Information sheet for introduction of MERIDA TEAM TR II dropper seat post

1. What's the change

We will replace the MERIDA TEAM TR (Limotec A8) with the new MERIDA TEAM TR II (Limotec H1) seat post.

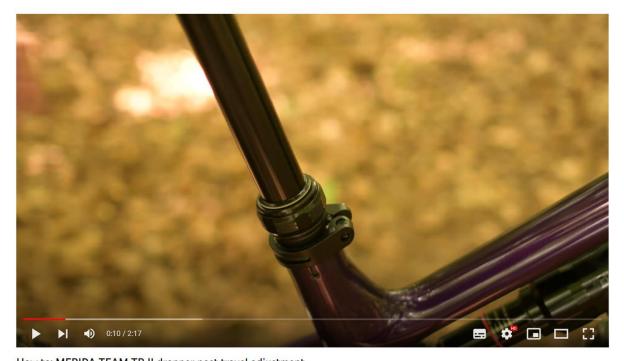
This seat post has the same unique travel adjustability from 40 mm to 230 mm, but is much more user-friendly, reliable and comes without the box on the side. The new seat post has a conical tube that can be fixed in all positions with the collar and doesn't need the orange rope.
